Design Review Subcommittee (DRSC)

Meeting Date: April 29, 2015

SUBJECT: Amendment to Site Plan Permit 97-16, Residential Architectural Amendments-Marblehead Coastal, a request to consider alternative elevations for 35 lots within the residential portion of Marblehead Coastal.

Image 1: Proposed Alternative Balcony

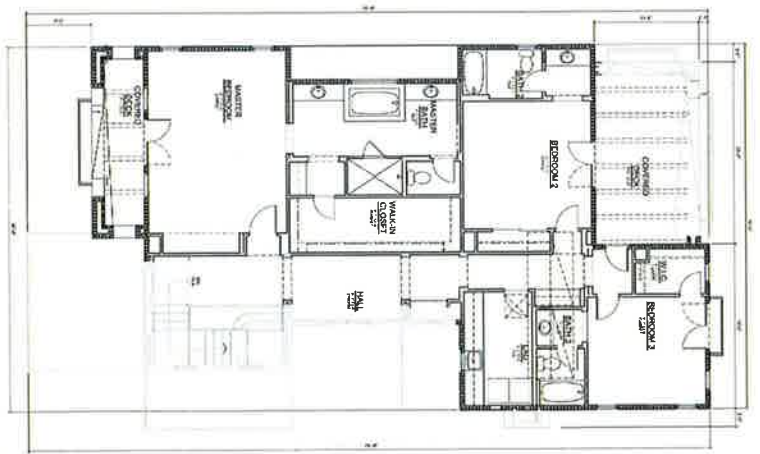
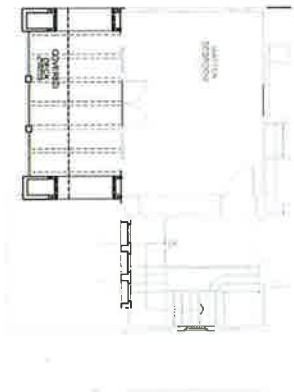
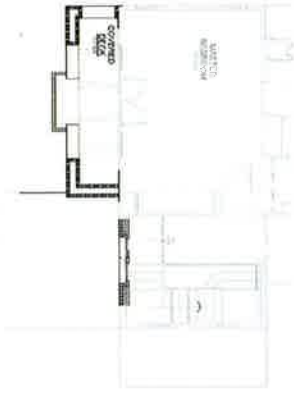
1. **Metal Balconies on the 2nd Floor-** For the alternative elevations labeled: 5000 1AX, 5000 1CX, 5000 3BX, and 5500 1AX the design of the balcony needs to be reconsidered. The applicant is proposing a stucco balcony that has an awkward opening to a wrought iron Juliet balcony. Staff recommends utilizing either all stucco, a different stucco/wrought iron approach, or some other balcony design to improve the look of this feature. Here is an image of what is proposed and an example of a potential alternative meeting the same design goals.

Image 2: Potential Revised Balcony
